Subject: Case File Review for Site Cleanup Program (SCP) Case RO0003201 and GeoTracker Global ID T10000008348, M & M Property Company LLC, 2800 Broadway, Oakland, CA 94612

Alameda County Department of Environmental Health (ACDEH) staff has reviewed the SCP case file for the above-referenced site, including the document entitled *Data Gaps Investigation Work Plan, M & M Property LLC, 2800 Broadway, Oakland, California*, dated March 17, 2017, prepared by LANGAN on your behalf. The Data Gaps Investigation Work Plan presents investigation activities to address data gaps and to prepare a site conceptual model (SCM) for the site. Proposed activities include a video survey of the sink drain inside the building which leads to a discharge point at the city sewer located somewhere beneath 28th Street; advancement of membrane interface probes (MIPs) and soil borings to facilitate soil and grab groundwater sample collection; and monitoring well installation.

TECHNICAL COMMENTS

SITE PLAN WITH PREVIOUS AND PROPOSED SAMPLING LOCATIONS

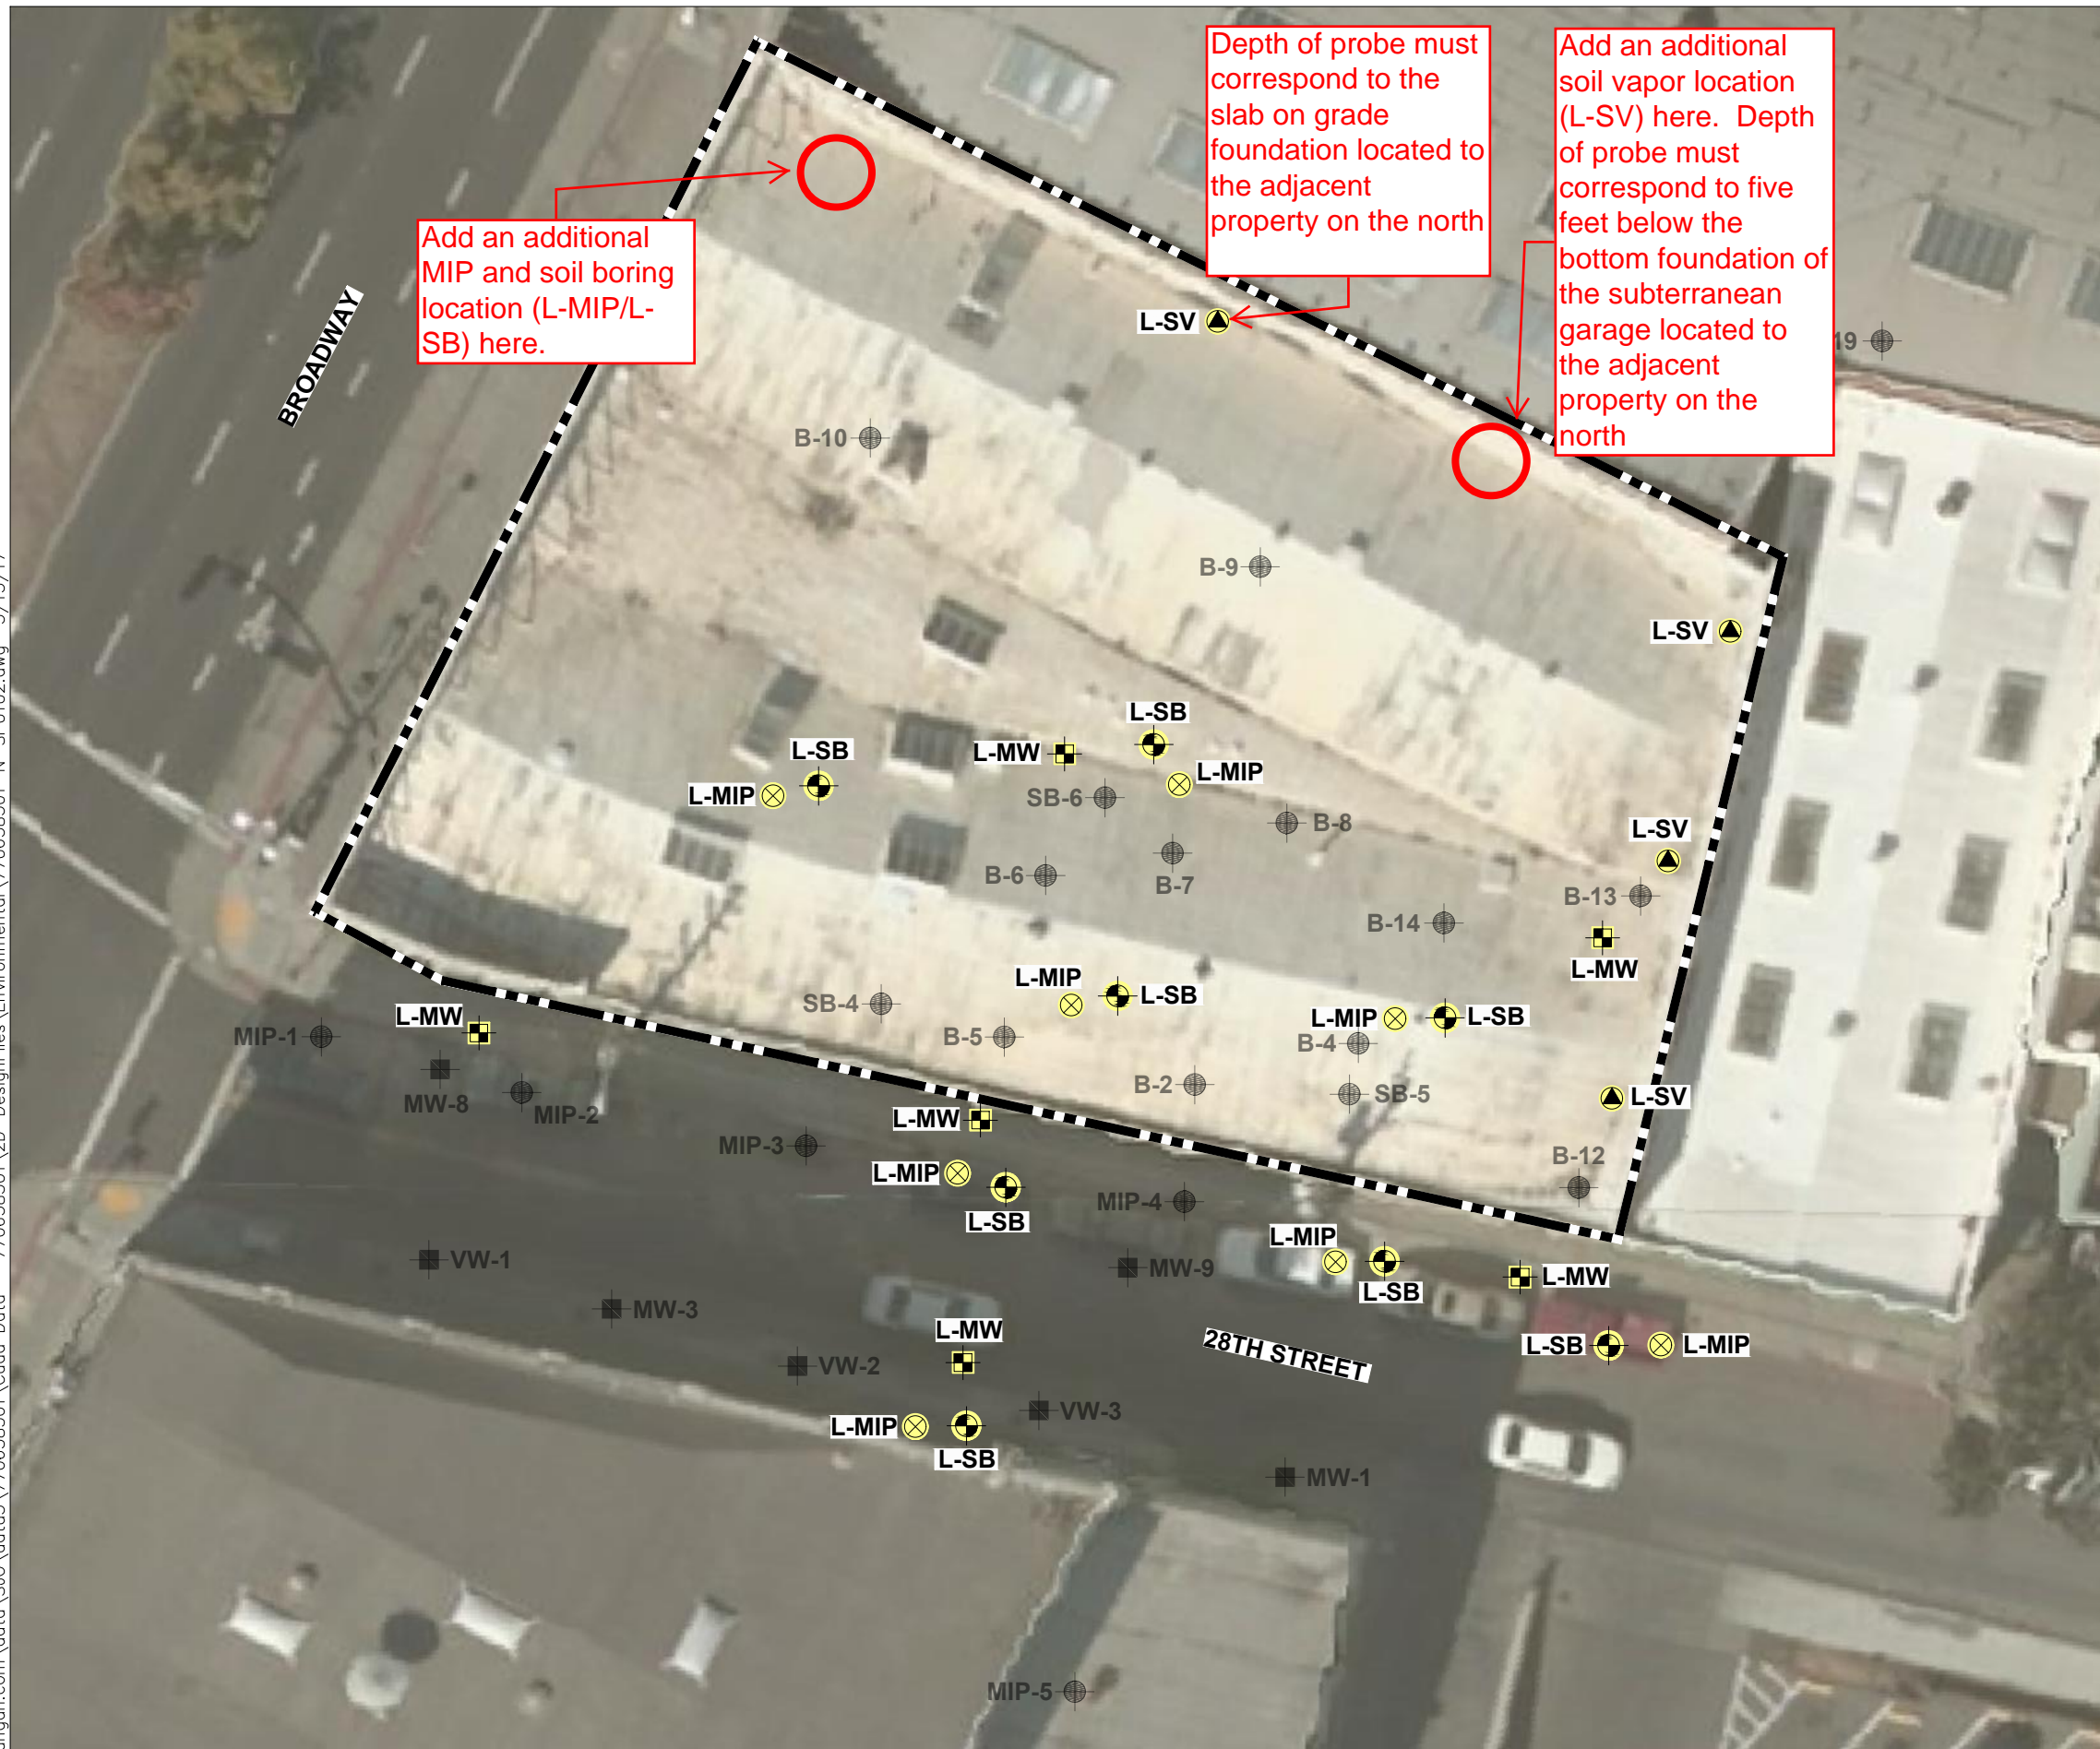
- Add an additional MIP/soil boring location to the scope of work. This location will be required to provide coverage on the northwest corner of the site where no soil or groundwater data is available. A grab groundwater sample will be collected based on the findings of the MIP/soil boring. See attached Figure 2.

- Add two additional soil vapor sampling locations to the scope of work. These locations are required to provide further evaluation of vapor intrusion risk to the adjacent property to the north. This will change the total of proposed soil vapor sampling locations from four to six locations. See attached Figure 2.

Add an additional MIP and soil boring location (L-MIP/L-SB) here.

Depth of probe must correspond to the slab on grade foundation located to the adjacent property on the north

Add an additional soil vapor location (L-SV) here. Depth of probe must correspond to five feet below the bottom foundation of the subterranean garage located to the adjacent property on the north
